June 8, 2019

**Re: Responses to DEP Comments for Hydrogeological HDD Re-Evaluation Report
LeTort Spring Run 16" Horizontal Directional Drill Location (S2-0210-16)
Permit No. E21-449
Middlesex Township, Cumberland County**

Larry J. Gremminger, CWB
Vice-President – Environmental, Health & Safety
Energy Transfer Partners
Mariner East 2 Pipeline Project

Figure 1: Permitted 16-Inch HDD Plan and Profile

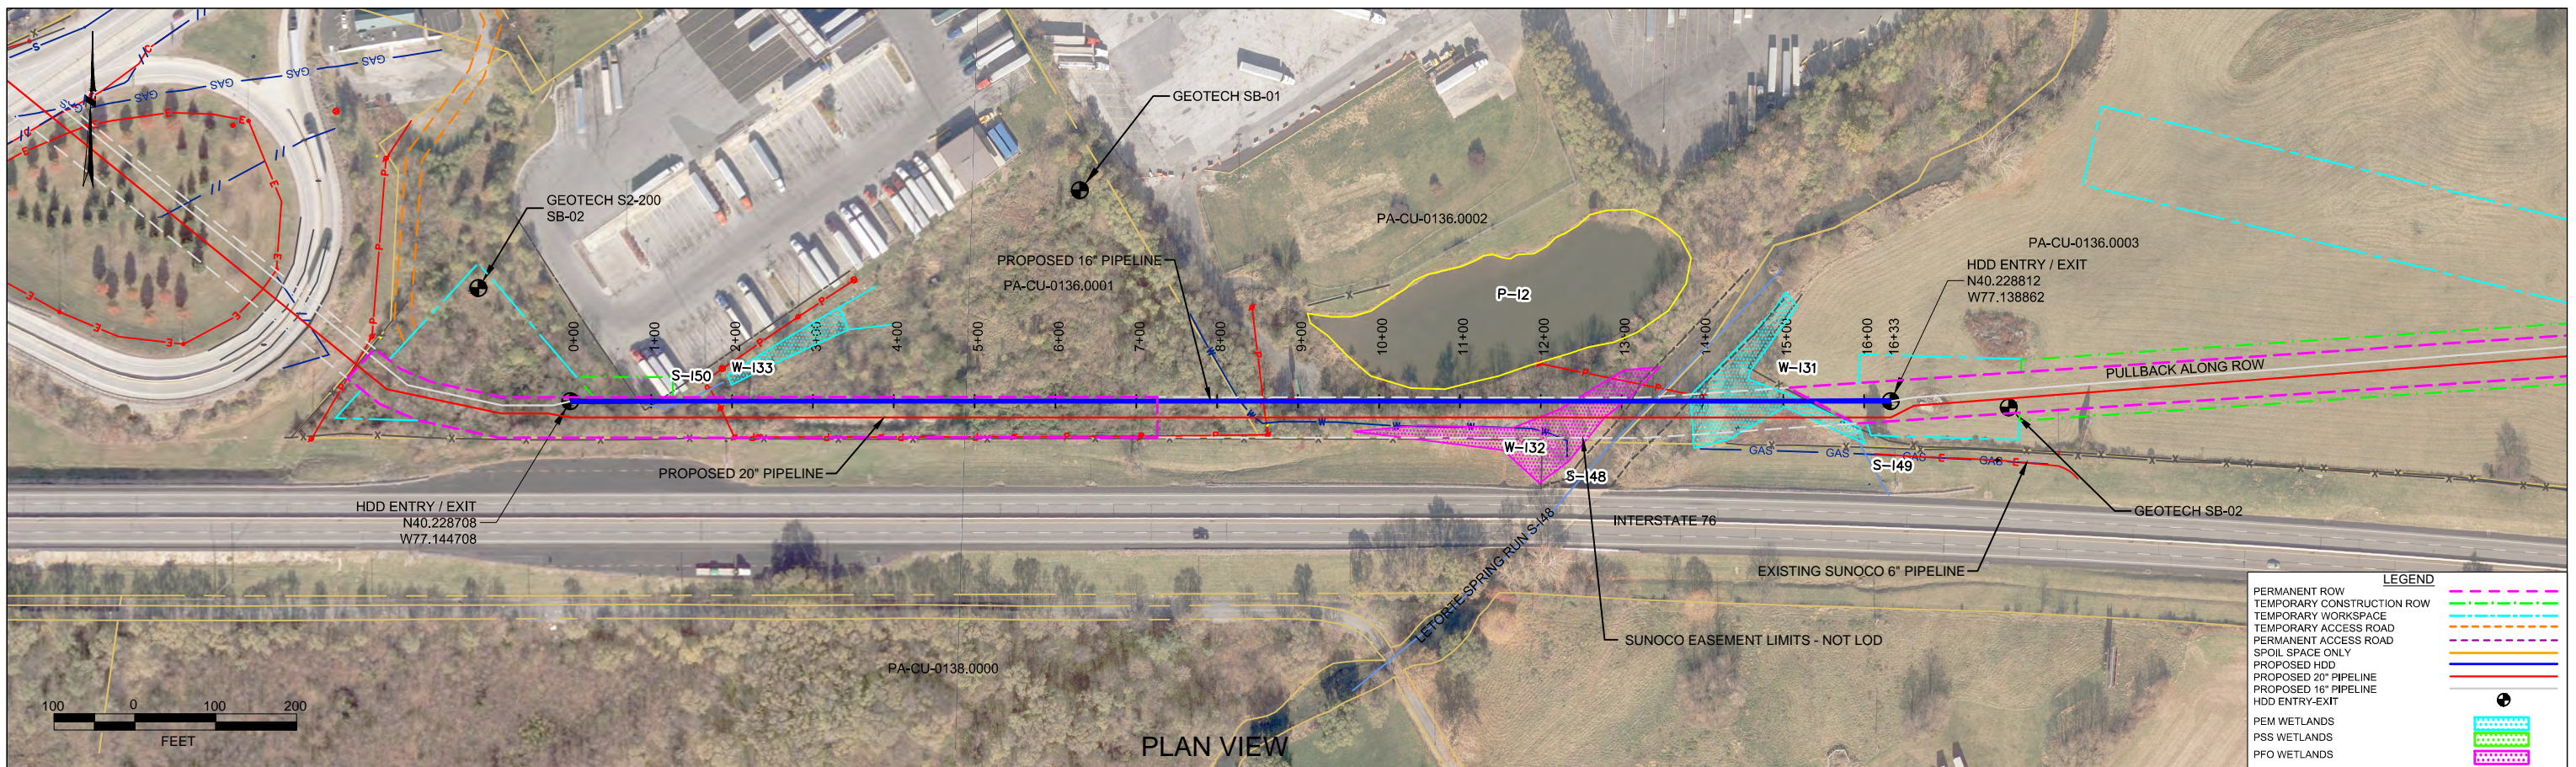
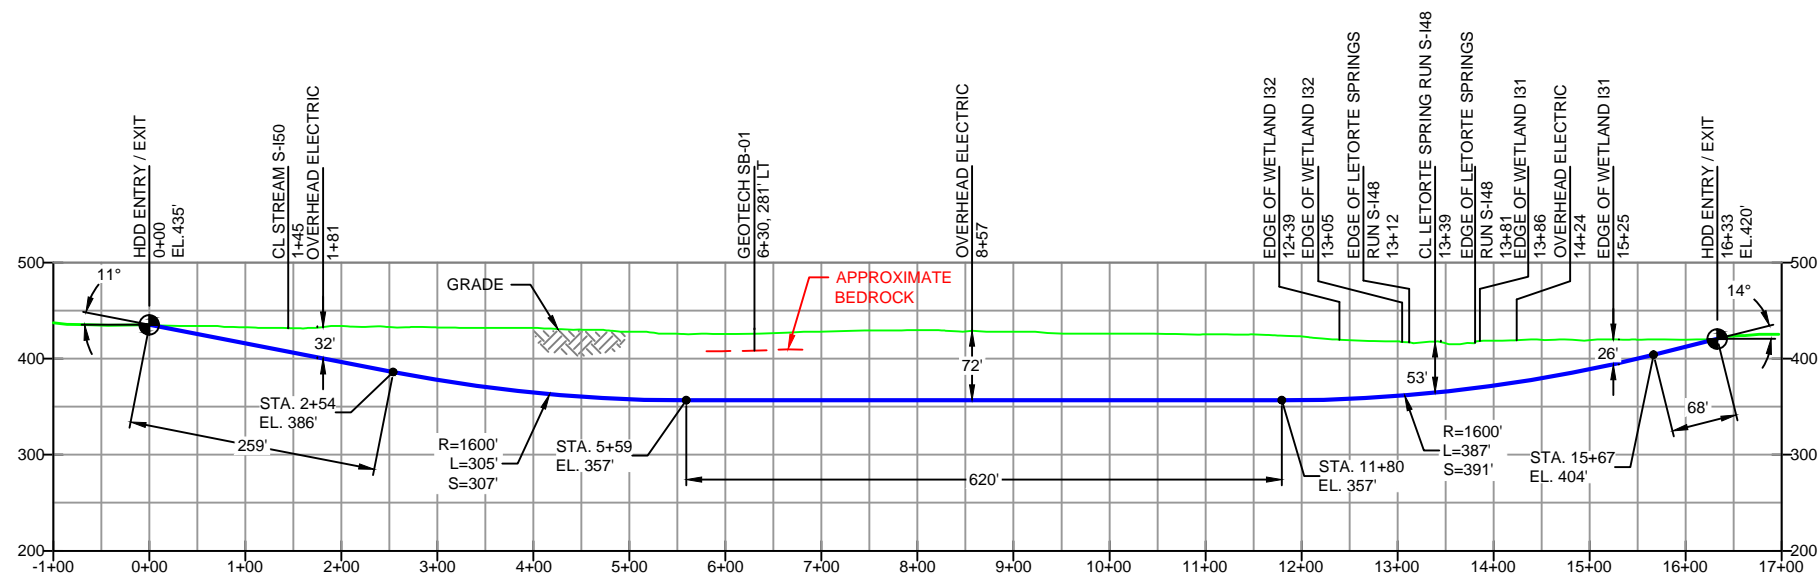
5. Please correct the inconsistency between the Entry/Exit Angles in the narrative and final profile drawings.

This information was utilized, along with the hydrogeologic evaluation, to evaluate the permitted 16-inch HDD for the likelihood of IRs during installation. Based on this review, it was determined that the permitted profile was susceptible to IRs. To reduce the potential of IRs during completion of the 16-inch HDD, the profile was redesigned and the entry and exit angles of the 16-inch HDD profile have been increased to allow the boring to advance through competent bedrock quicker and

closer to the entry/exit points. Further, the overall depth of the profile has been increased from a maximum depth of 133 feet below ground surface on the permitted 16-inch profile to 144 feet bgs on the redesigned 16-inch profile. This will allow for more of the boring to be advanced through bedrock containing higher rock quality designation (RQD) values. The RQD values for the 20-inch profile were generally considered good; however, to further reduced the potential of IRs during the installation of the 16-inch HDD, the profile was designed to intersect more competent bedrock and avoid intervals of bedrock which contained multiple fractures as identified in the 2017 geotechnical investigation.

Figure 2. 20-Inch As Drilled HDD Plan and Profile with IR Data

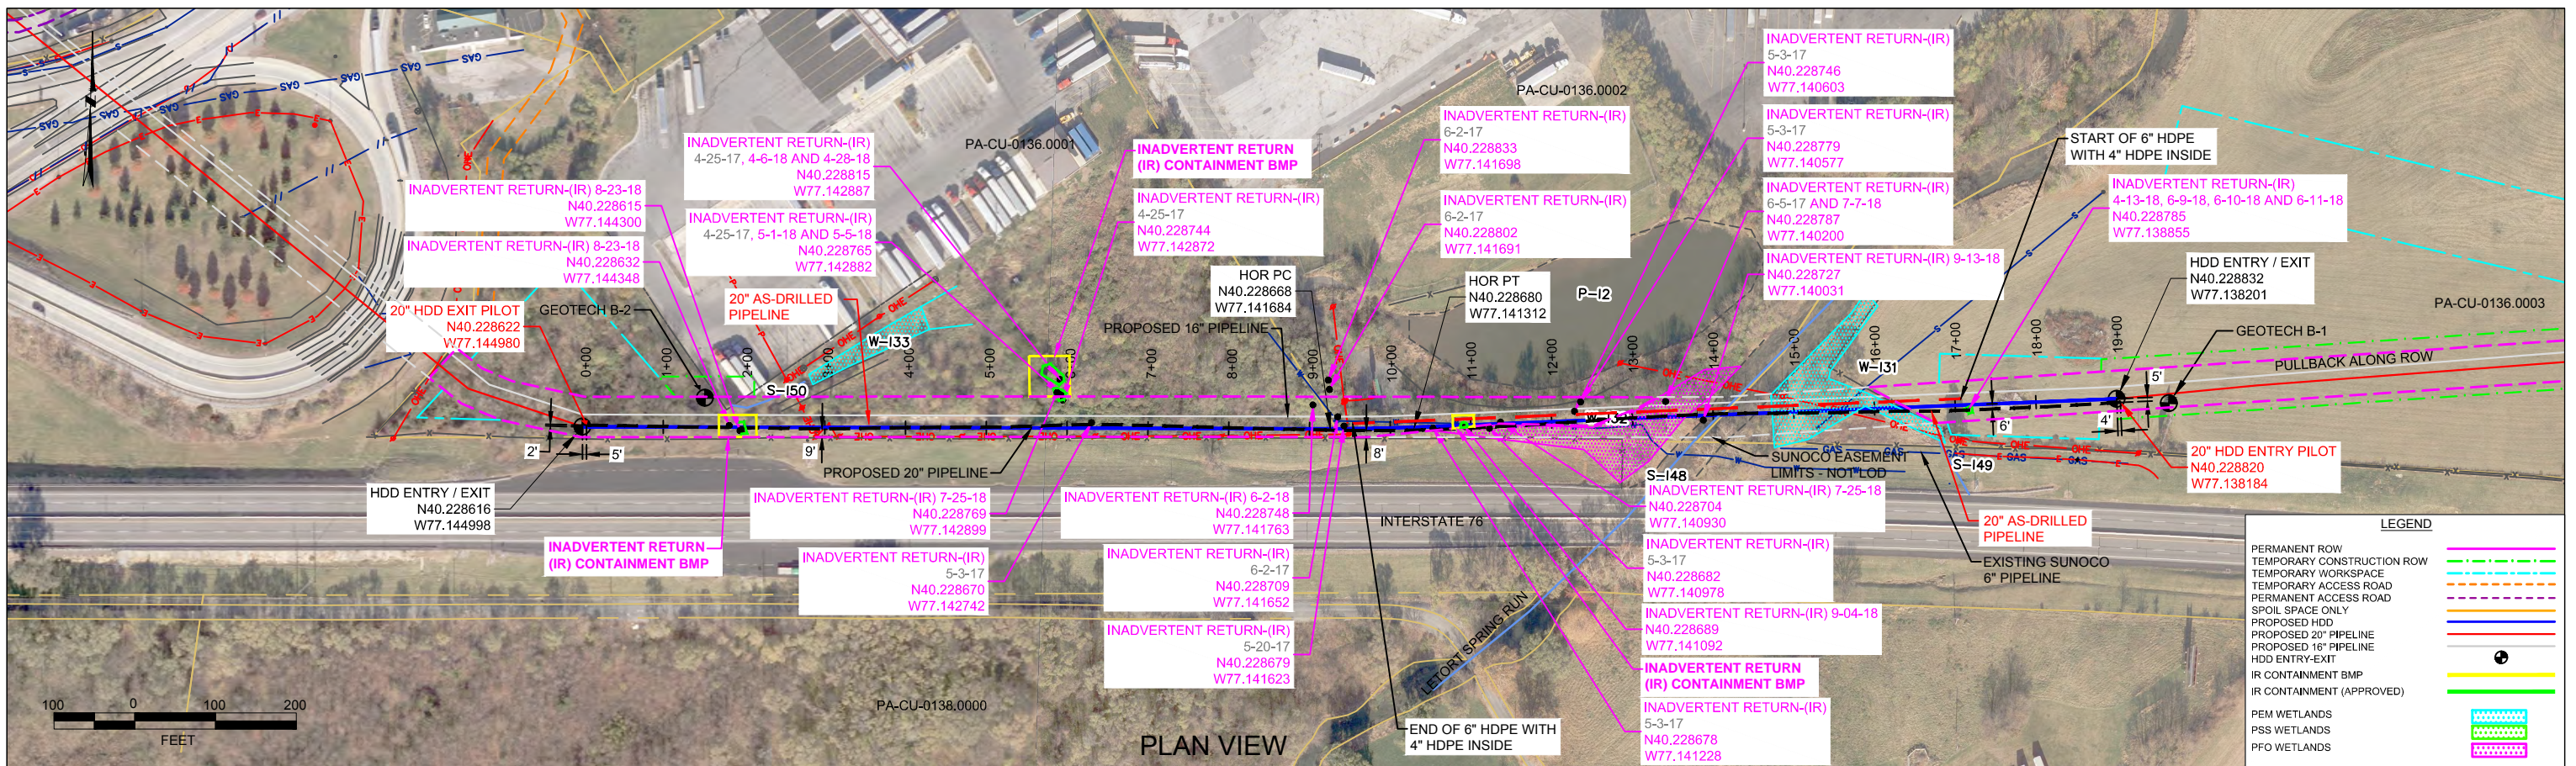
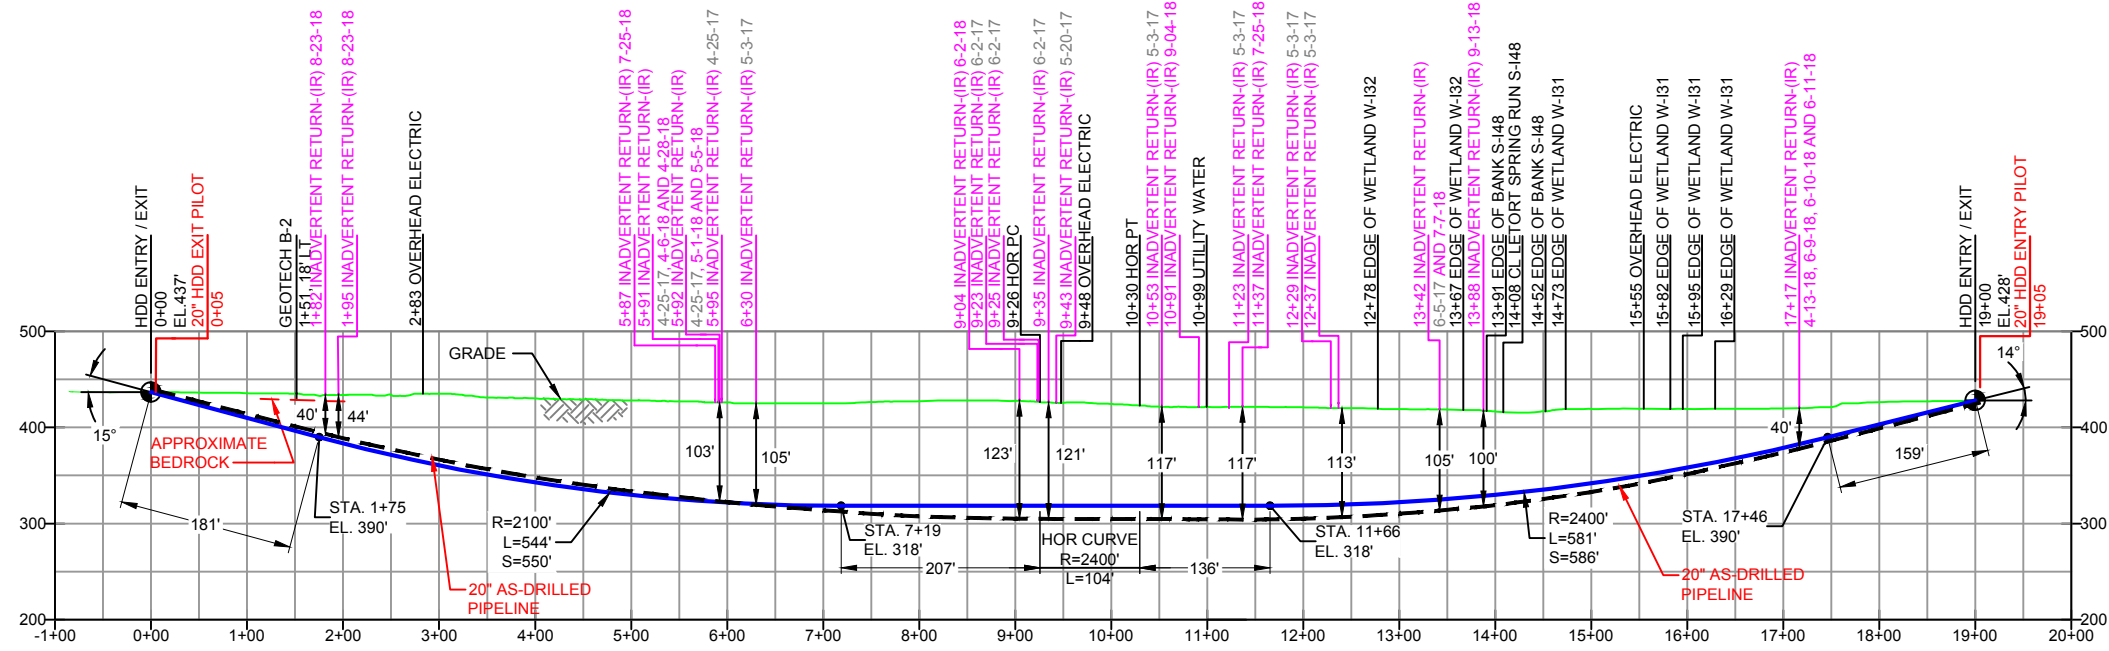
- 1. As required by Paragraph 4 and 5 of the Environmental Hearing Board's August 10, 2017 Corrected Stipulated Order, SPLP failed to fully utilize information gathered during the HDD of the 20-inch bore as part of the HDD Re-evaluation for the 16-inch pipeline. Many small inadvertent returns occurred during the HDD activities for the 20-inch bore. Please gather geologic and drilling information collected by various site personnel during the 20-inch bore which can be used to synthesize a comprehensive history of each or groupings of events. The HDD re-evaluation report should discuss the operational or geologic cause of each inadvertent return, the magnitude of the inadvertent return(s) and associated loss of circulation, the best management practice used to contain and minimize the inadvertent return, and the drilling procedure or technique used to progress the boring.**

This information should then be used to describe why the chosen bore path for the 16-inch pipeline was determined and how such information has been used to minimize the potential for IR's to occur. Also, as part of the discussion of construction alternatives, include why HDD activity is still the preferred and chosen methodology for pipeline construction at this location.

SPLP utilized all information obtained during the drilling of the 20-inch HDD in our internal assessment and evaluation of the 16-inch HDD profile as revised; however, we understand that

our deductions from review of this information were not clearly conveyed in the Reevaluation Report. It should be noted that the Inadvertent Return (IR) information shown on Figure 1 in Attachment 2 presents the plan and cross section views of IR events that occurred during the 2017 pilot hole attempt and 2018 pilot hole drilling, reaming, and completion of this HDD. This figure presents the reality of events that occurred during this HDD in relation to the depth of profile and the allowed for correlation to monitoring data collected during active drilling.

SPLP reviewed the daily drilling reports, the geotechnical investigations, IR Restart Reports and the HDD Inspection Daily Reports, paying attention to intervals/days in which a partial or full loss of returns or an IR occurred. Specifically, the depth of the bit was compared to the geotechnical investigations to determine if the pilot tool and/or reamer was advancing through an interval of bedrock which was either highly fractured or weathered. Further, the annular and mud pressures were reviewed to identify any sudden changes in pressure, which could be utilized to approximate the competency of the bedrock.

A review of this information indicated that the losses in returns and IRs resulted from the 20-inch boring passing through intervals of weathered and/or fractured bedrock that also communicated with IRs associated with the original 2017 20-inch borehole. This communication resulted in IRs 1 through 6 identified on the redesigned 16-inch HDD profile (Figure 2) contained in Attachment 2 of the February 6, 2019 Re-Evaluation Report. The seventh IR identified on the redesigned the 16-inch HDD profile resulted from the 22-inch reamer passing through an interval of bedrock which was likely highly fractured and weathered as inferred from the regional strike and dip and the lithologic description in Boring B-1.
